**Subject:** U.S. EPR Design Certification Application RAI No. 241 (2769, 2804),FSAR Ch. 15

**Response to**  
**Request for Additional Information No. 241, Supplement 1**

**U.S. EPR Standard Design Certification**  
**AREVA NP Inc.**  
**Docket No. 52-020**

**SRP Section: 15.06.05 - Loss of Coolant Accidents Resulting From Spectrum of  
Postulated Piping Breaks Within the Reactor Coolant Pressure Boundary  
Application FSAR Ch 15**

**Figure 15.06.05-51-1—Modeled Steam Flow Paths and Elevations**

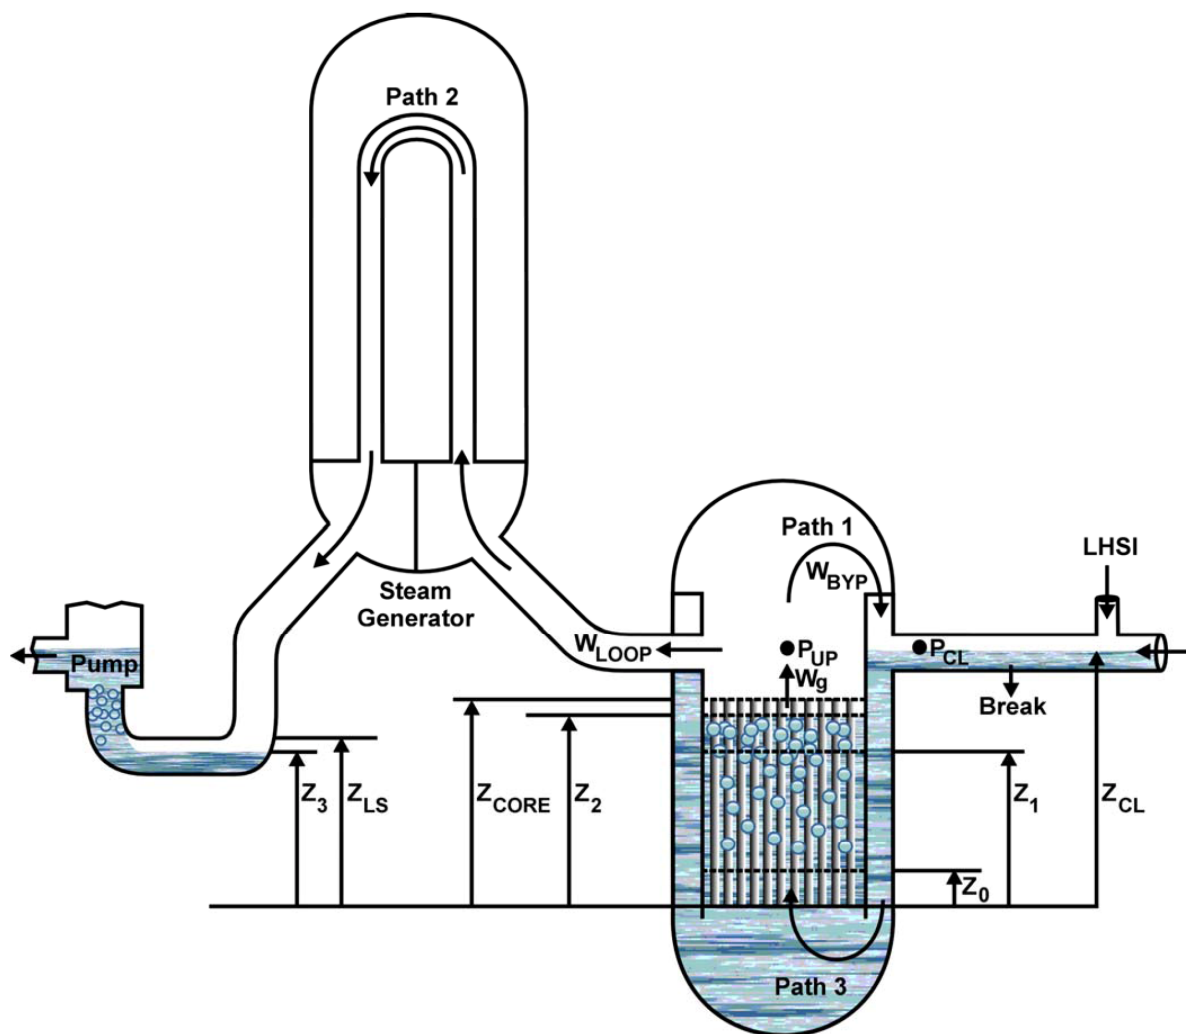
Please provide the results of a thermal-hydraulic analysis quantifying the two-phase mixture level within the reactor core barrel during the long term cooling of the U.S. EPR core under the most limiting break size, break location and ECCS performance conditions. Discuss the conservatism of the obtained results. For important modeling parameters that are expected to vary within a certain range, substantiate the conservatism in selecting the value for each parameter or provide sensitivity assessments over the expected range of variation.

Figure 15.06.05-51-1 shows the concept and essential features of the quasi-steady static-balance model. The assumptions and description are as follows:

- 5) A cold leg break between the reactor coolant pump and reactor vessel is the most limiting location because of restricted steam venting through the loop seal as shown in Figure 15.06.05-51-1. Other break locations do not impose significant limitations to the venting of steam and do not cause a depression of the collapsed liquid level in the core. The analysis is independent of break size and geometry because of the conservative assumption that LHSI maintains postulated water levels.

- 1) High decay power in the post-reflood period causes the steam generated within the active core to vent through Path 1 and Path 2 as shown in Figure 15.06.05-51-1. The water elevation  $Z_3$  is depressed sufficiently to allow steam to pass through the loop seal. The two-phase mixture in the vertical leg on the pump side of the loop seal reduces the hydraulic head and the core collapsed liquid level,  $Z_1$ , is near the elevation of the cold leg. Thus, the collapsed liquid level is well above the TAF. The two-phase mixture level,  $Z_2$ , is also well above the TAF.

**Figure 15.06.05-52-1—Water Inventory in the Five Sub-Volume Core Concentrating Region**

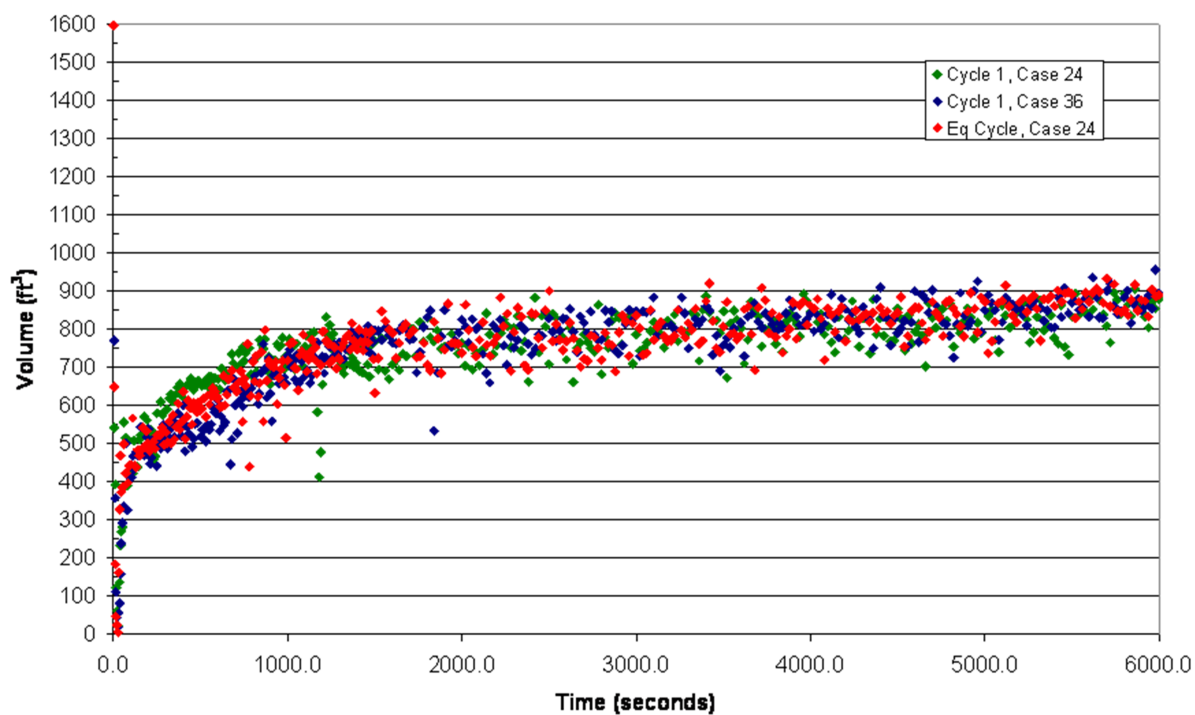
As the predicted precipitation time is proportional to the assumed liquid content within the mixing volume chosen, please demonstrate that the void fraction values, as applied to the individual mixing sub-regions, are conservative under the thermal hydraulic conditions encountered in the sub-regions over the period of interest. In particular, substantiate the applicability of a single void fraction value for computing the liquid amount within an entire sub-volume and explain any averaging assumptions with respect to both space and time.

concentrating region were re-run with the transient analysis extended to 6000 seconds. The recirculation pattern through the five sub-volumes developed with the downflow rates exceeding the evaporation rate at 1000 seconds into the transient. As shown in Figure 15.06.05-52-1, the three cases show that the volume in the five sub-volume concentration volume exceeds the 617 ft<sup>3</sup> used in the original analysis with 750 ft<sup>3</sup> to 900 ft<sup>3</sup> at 6000 seconds. Although all three of these cases contained less water at the end of the PCT analysis than the original analysis, the analysis of the three cases with a time-dependent volume showed that the original assumption was conservative.

**Figure 15.06.05.55-1—Post-Quench LBLOCA Recirculation Depiction**

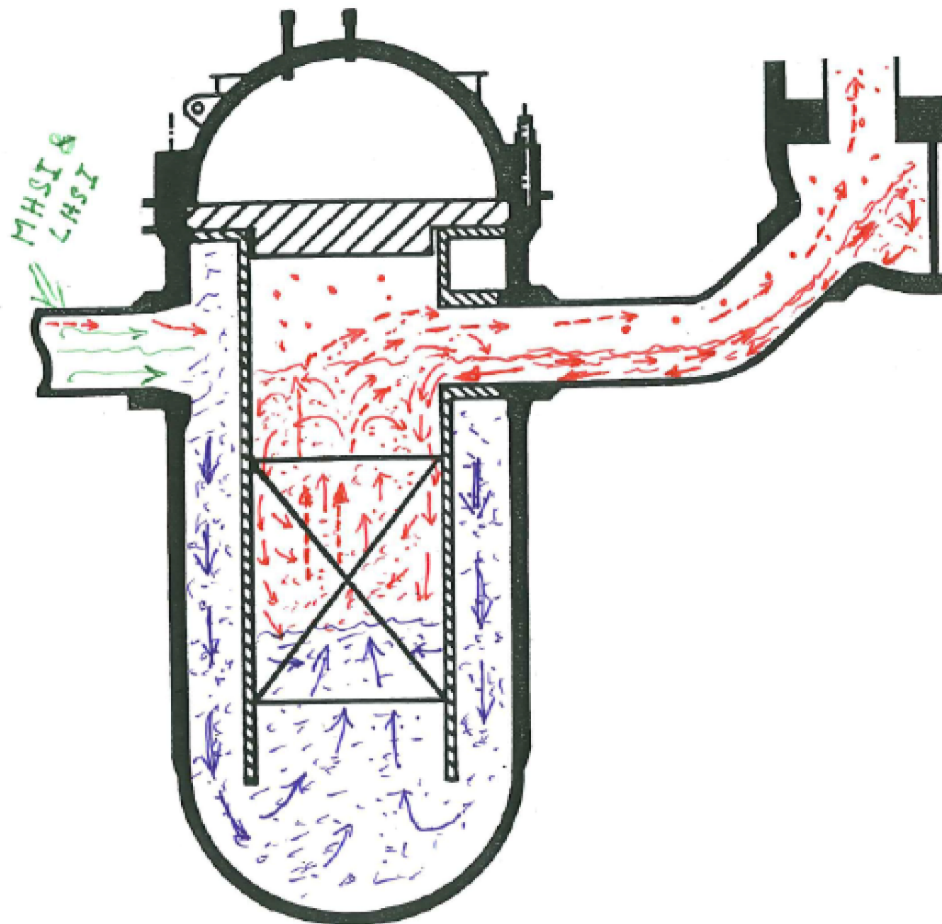
As liquid coolant is evaporated within the active core region, the dissolved boron is deposited, almost entirely, in the liquid surrounding the heated fuel surface where the evaporation process occurs. Since the predicted time to precipitation is proportional to the assumed liquid content in the defined mixing volume, please provide substantiation for the inclusion of any liquid containing regions outside of the active core in the mixing volume and explain the mechanisms capable of transporting and mixing liquid within the core region, and from the core region into any additional volumes included in the mass balance mixing volume. In addition, provide evidence that the end result of these mechanisms is perfect boric acid mixing within the liquid phase in the entire control volume as assumed in the calculations.

The five regions were selected as the concentrating volume due to the recirculation pattern which develops post-quench in a large break loss-of-coolant accident (LBLOCA) (see Figure 15.06.05-55-1 and Figure 15.06.05-55-2). Following a LBLOCA the core steams steadily at a rate corresponding to the decay heat in the reactor core. Prior to recirculation, the core is steaming and the concentration of boron in the core increases at its fastest rate. When the heavy reflector and guide tube regions are sufficiently cooled, the flow leaving the core enters the upper plenum and either exits as steam through the hot legs or recirculates to the lower plenum. The steam exits the core via the hot legs and proceeds to the steam generators where it is further heated as it cools the secondary side. The water, on the other hand, increases the static pressure head next to the core barrel. The denser water tends to accumulate over the heavy reflector and peripheral fuel assemblies. This water then proceeds down the low power
